Ref: D2068.24

Ref: The Spinney Pulborough, RH20 2AP - DC/24/0068

Drainage Department Recommendations:

Consultant Response:

Building Regulations Extract & DCG Extract, respectively.

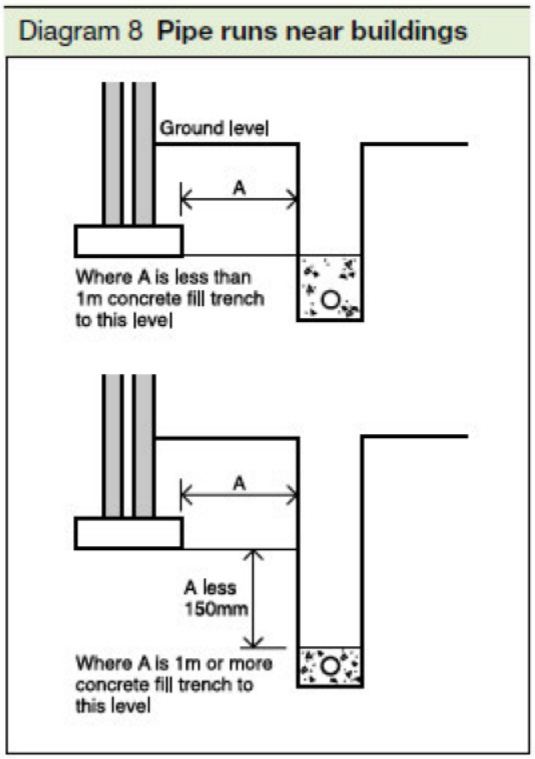
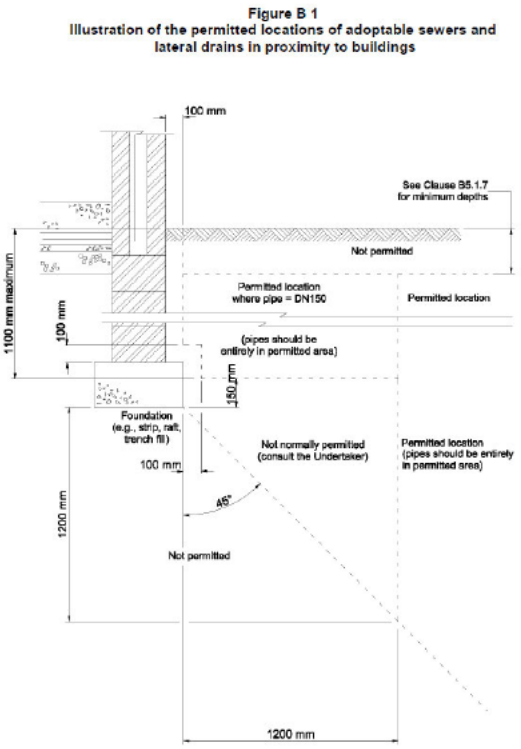
8) The detailed foul drainage strategy layout has been designed to account for the proposed peak foul flows generated by two dwellings. The invert levels of the foul water network have not been provided, but the application does not provide clear evidence if foul water pipes are too close to buildings or within the line of influence of the foundations. The applicant must demonstrate that both the surface water and foul water pipes will be set 1.2m clear from the foundation external face, or otherwise not within the line of influence of the building foundations, in accordance with Sewerage Sector Guidance: Design and Construction Guidance.

a) There is no need to demonstrate that pipework will be minimum 1.2m from the buildings, as there is no intention to propose the drainage network for adoption. The drainage system therefore will be designed to suit Building Regulations Part H – diagram 8 on page 15 of this guidance details concrete trench fill requirements for drainage systems adjacent buildings and this will be detailed further in accompanying construction details alongside a drainage and civils design for discharge of conditions.

(The reviewing drainage team should also note that DCG allows for shallow drainage as close as 100mm from a building exterior providing this is above foundations, so that would be something agreed upon at detailed design, alongside a structural engineer, if necessary.)

Drawing No.	Rev.
D2068.24 PL301	B

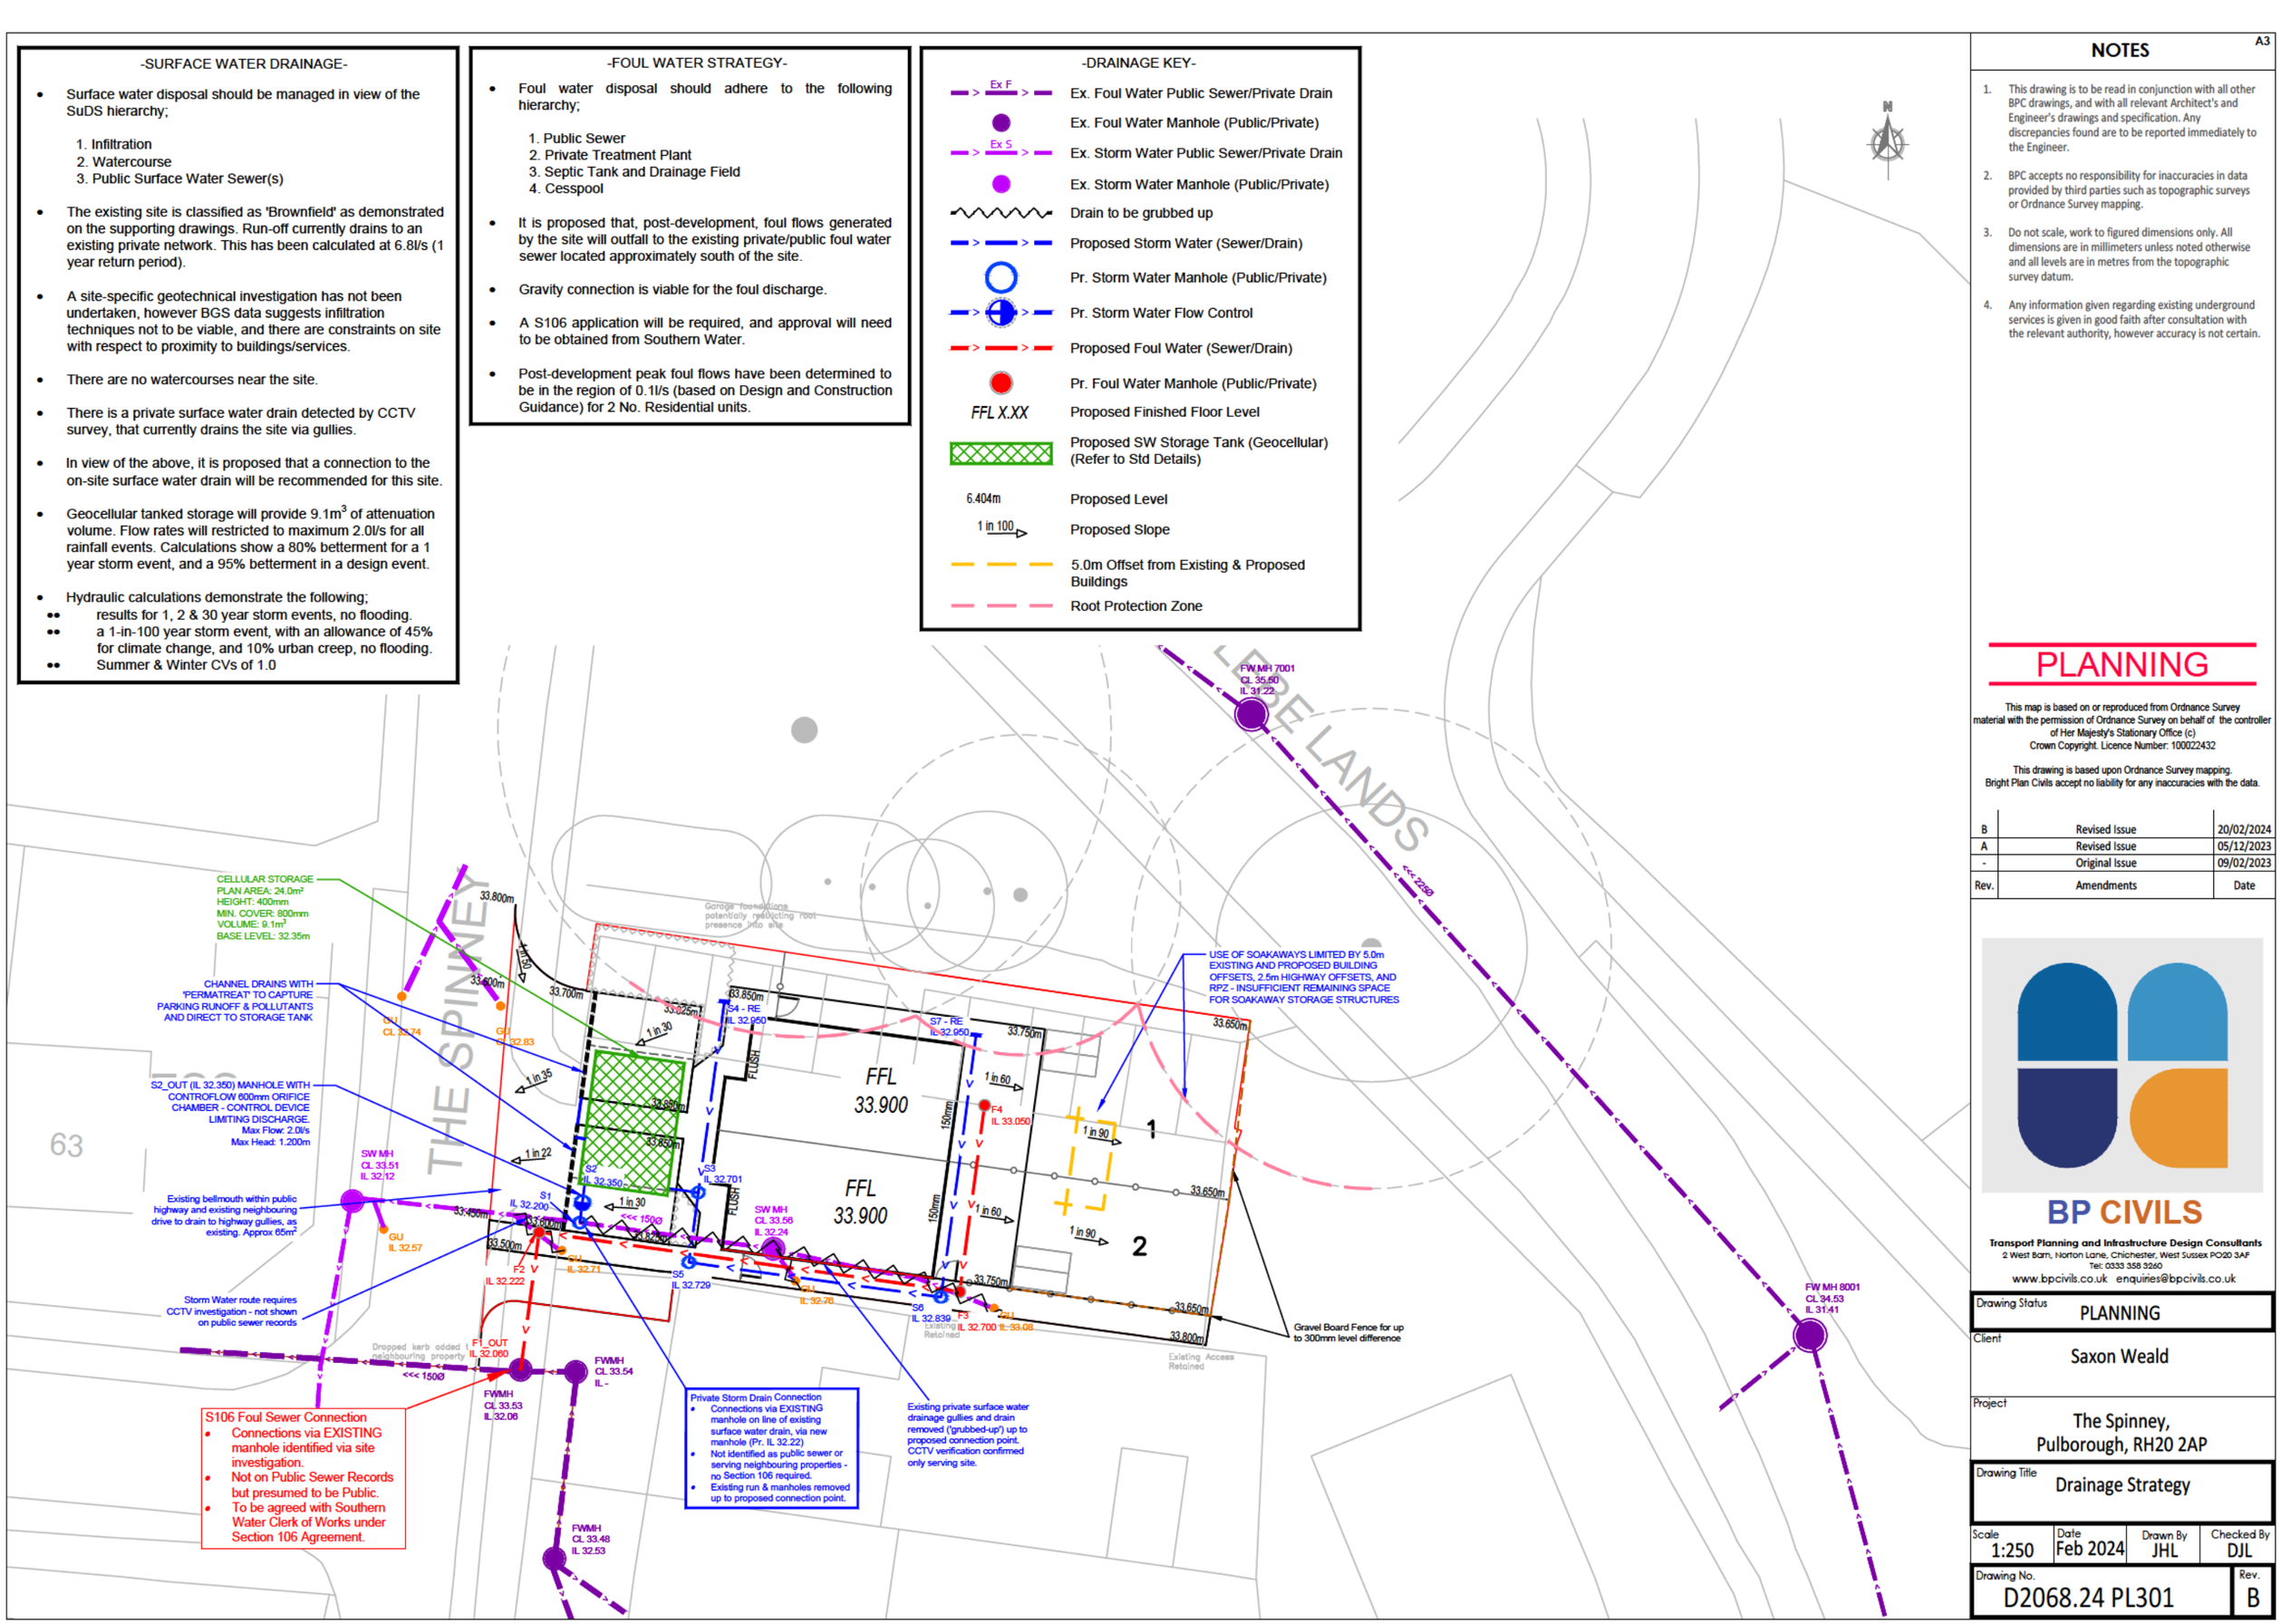
1) The applicant has not provided sufficient evidence to confirm or discount the potential for infiltration. The soil and geology identified in the desk study are potentially suitable material for infiltration. The Horsham District Council SFRA-Appendix 1 Figure 4 SuDS Suitability indicates suitability across the district council area for the provision of infiltration SuDS features. This product notes the site to lie in an area of moderate infiltration suitability.

Several constraints have been highlighted by the applicant, including proximity to buildings and the presence of a water supply trunk main. The location of the water supply trunk main has not been identified on a plan.

The applicant must highlight all constraints on a plan to determine available space for infiltration devices.

A site specific estimate for existing brownfield runoff rate should be provided: including the 1 in 1, 1 in 30 and 1 in 100 year storm events storm events.

5) The applicant has incorrectly set urban creep to 0%. An allowance of 10% for urban creep should be used, as per Section 5.6.4 of the West Sussex LLFA Policy for the Management of Surface Water.

7) Consideration of how exceedance flows for events greater than the 1 in 100 year plus climate change event will be managed and mitigated on site without significantly increasing flood risks (both on site and outside the development) should be provided. The applicant should confirm whether a 150mm finished floor level freeboard above surrounding ground levels is proposed to mitigate against the residual risk from surface water exceedance events. Proposed site levels and resulting surface water exceedance routes should be provided for the proposal.

1) Please see attached survey and revised plans which show the Trunk Main. This is in a different position to that previously shown on Southern Water maps, but nevertheless a number of constraints prevent use of soakaways, as agreed previously, due to insufficient space remaining when allowing for a 5.0m buffer from existing and proposed buildings, a 2.5m highway buffer, and root protection zones. Very little room is left following allowance for all these constraints, and this would be insufficient for soakaway storage structures big enough to support drainage of this site.

- In view of the above, it is proposed that a connection to the on-site surface water drain will be recommended for this site.
- Geocellular tanked storage will provide 9.1m^3 of attenuation volume. Flow rates will restricted to maximum 2.0l/s for all rainfall events. Calculations show a 80% betterment for a 1 year storm event, and a 95% betterment in a design event.

- Hydraulic calculations demonstrate the following;
  - results for 1, 2 & 30 year storm events, no flooding.
  - a 1-in-100 year storm event, with an allowance of 45% for climate change, and 10% urban creep, no flooding.

Trunk Main location confirmed following further investigation.
6m buffer is applicable for a pipe crown 1.5m deep.

PROPOSED BUILDING CONFIRMED NOT WITHIN TRUNK MAIN BUFFER, AND THE CLEARANCE COMPARED TO THE EXISTING BUILDINGS HAS BEEN INCREASED.
